Appendix D – Aerial Ignition Equipment Modifications

Subject: Aerial and Ground Ignition Equipment Direction

Subject: Required Safety Modifications: Batch Mixer, Terratorch, Mix Transfer System, and Helitorch

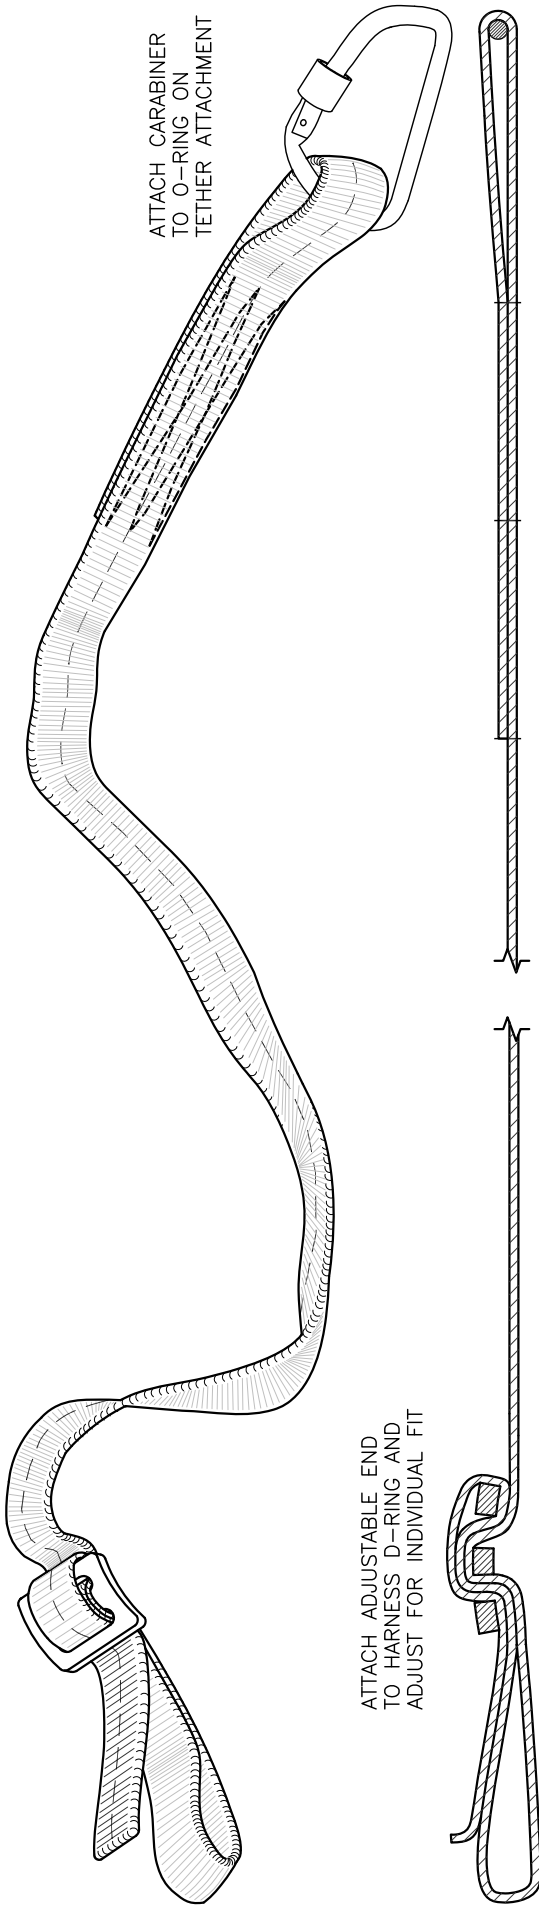
The Interagency Aerial Ignition Working Group requested approval of the following modifications of the Premo MK III by Premofire Canada Ltd:

- Hopper Agitation Plate
- Hopper to Feed Chute Attachment Pin
- New Exit Chute Design
- One Piece Stainless Steel Needles
- Needle Valve Lock Nuts
- Push Button Bleed Valve
- Flexible Tubing
- Manifold Cleanout Plugs
- Longer Belly Strap
- Belly Strap Attachment Points
- New Belly Strap Buckle
- Aluminum Storage and Transportation Box

The Premo Mark III was tested by MTDC and then used in the field with positive results. The purchase and use of this device will be included into the 2010 Interagency Aerial Ignition Guide. The IHOps Steering Committee along with NIAC has approved the purchase and use of the Premo MK III with modifications.
